Construction Traffic Management Plan - The Bays Metro Station Construction Site

SMWSTCTP-AFJ TBY TF PLN-000001 Revision 07

Sydney Metro West Central Tunnelling Package

PRECONSTRUCTION - DESKTOP ROAD SAFETY AUDIT

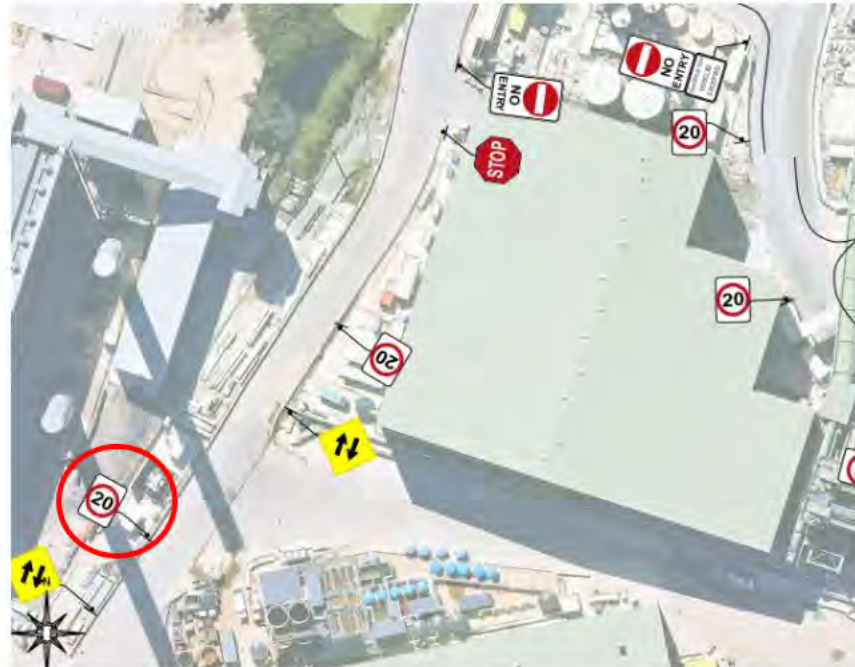
No.	Drawing No.	Description of Deficiency / Observation	Risk level
1	Stage 1 - AFJVCTP-TGS-00797 (page 2 of 6)	<p>The audit team observed a single 20km/hr speed zone sign is proposed on the SB approach of Port Access Road. The audit team realise that this road is to be used by authorised motorists (i.e. not open to the general public), however, the TCAWS manual recommends at the start of speed zones, that speed limit signs are to be erected on both sides of the carriageway, where this is not possible a second sign is to be erected 0.5D from the start of the zone. It is not clear if the speed zone is 20km/hr prior to this initial sign, hence this finding has been included. Inadequate advance warning of speed zone changes may increase the likelihood of motorists noncompliance which may increase risk exposure to all road users & the workforce.</p> 	<p>Likelihood – Unlikely Severity – Minor Risk Rating – Low</p>

Item	Location	Comment	Client's Response/Action for Resolution
1	Stage 1 - AFJVCTP-TGS-00797 (page 2 of 6)	The audit team observed a single 20km/hr speed zone sign is proposed on the SB approach of Port Access Road. The audit team realise that this road is to be used by authorised motorists (i.e. not opene to the general public), however, the TCAWS manual recomments at the start of speed zones, that speed limit signs are to be erected on both sides of the carraigeway, where this is not possible a second sign is to be erected 0.5D from the start of the zone. It is not clear if the speed zone is 20km/hr prior to this initial sign, hence this finding has been included. Inadequate advance warning of speed zone changes may increase the likelihood of motorists noncompliance which may increase risk exposure to all road users & the workforce.	Noted, traffic is generally only construction or cruise traffic, coming from a low speed environment, speed signs are also repeated at consistent spacings through the site.

2 Stage 1 - AFJVCTP-TGS-00797 (page 3 of 6)

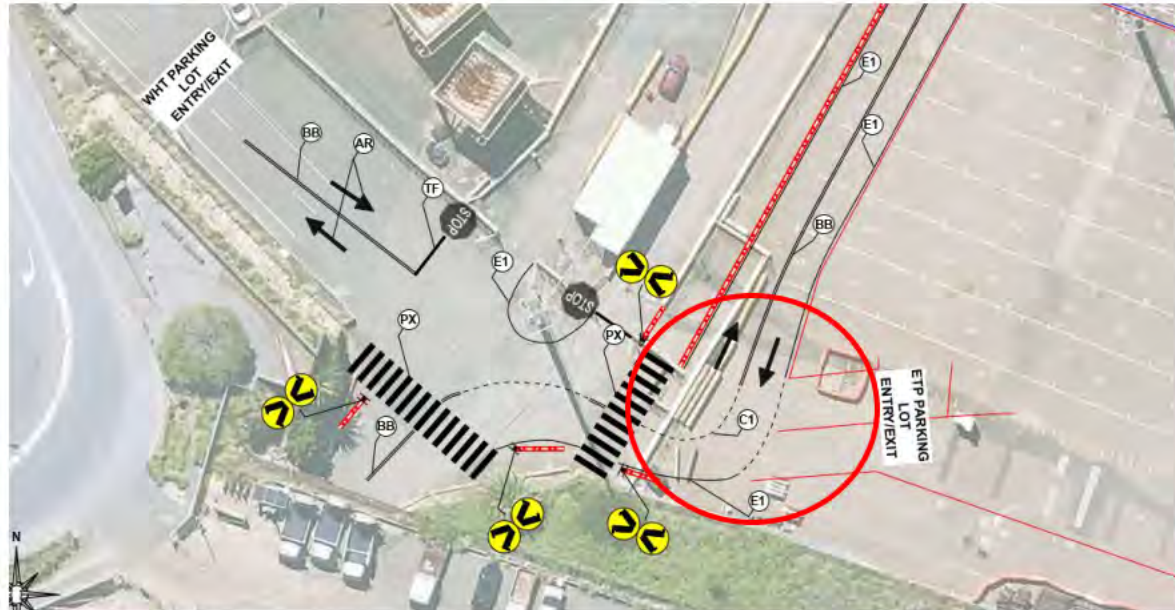
Likelihood – Unlikely
Severity – Minor
Risk Rating – Low
